# Access Compliance Report

### (Curb Ramps)

Intersection ID: N/A	Main Street: INDEPENDENCE_DR	Cross Street: CONFERENCE_DR	Location: N
ADA ID: DD3DE6EFB3D9	Ramp Type: Perp	Initial Pass/Fail: Fail	Overall Compliance: No
Codes/Mitigation Info/Possible Solution		Field Measurements/Component Compliance

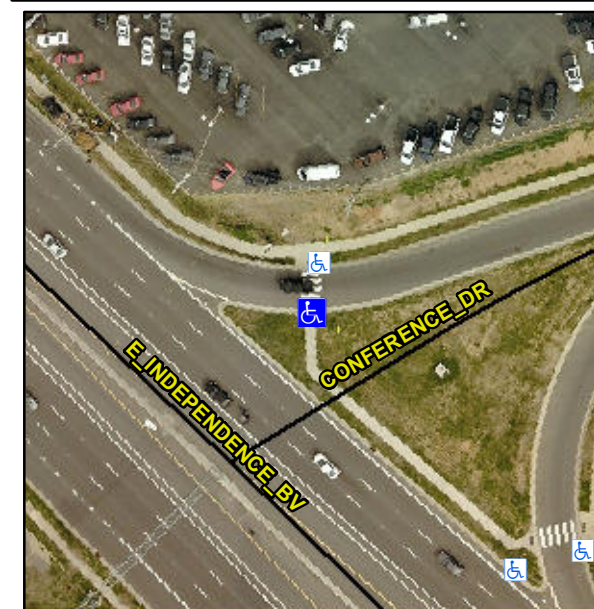
**Not Found, R304.2.2**

Compliance	Description	Data	Compliance	Description	Data
N/A	Ramp Length (in)	70.0	No	Ramp Slope (%)	8.5
Yes	Ramp Width (in)	59.0	Yes	Ramp XSlope (%)	2.2
N/A	Flare Type LT	N/A	N/A	Flare Type RT	N/A
N/A	Flare Slope LT (%)	N/A	N/A	Flare Slope RT (%)	N/A
N/A	Flare Traversable LT?	N/A	N/A	Flare Traversable RT?	N/A
N/A	Landing Length (in)	N/A	N/A	DWS Provided?	N/A
N/A	Landing Width (in)	N/A	N/A	DWS Contrast?	N/A
N/A	Landing Slope (%)	N/A	N/A	DWS Length (in)	N/A
N/A	Landing X Slope (%)	N/A	N/A	DWS Full Width?	N/A
N/A	Landing Curb? (Y/N)	N/A	N/A	DWS Offset (in)	N/A
N/A	Shared Landing?	N/A			
N/A	Gutter Ponding?	N/A	N/A	Gutter Slope (%)	N/A
N/A	Gutter Lip Ht (in)	N/A	N/A	Gutter X Slope (%)	N/A
N/A	Painted X Walk1?	Yes	N/A	Painted X Walk2?	N/A
	X Walk 1 Direction	To N		X Walk 2 Direction	N/A
N/A	X Walk 1 Width (in)	121.0	N/A	X Walk 2 Width (in)	N/A
	X Walk 1 Slope (%)	7.0		X Walk 2 Slope (%)	N/A
	X Walk 1 X Slope (%)	4.0		X Walk 2 X Slope (%)	N/A

**Remove & Replace Entire Ramp.**
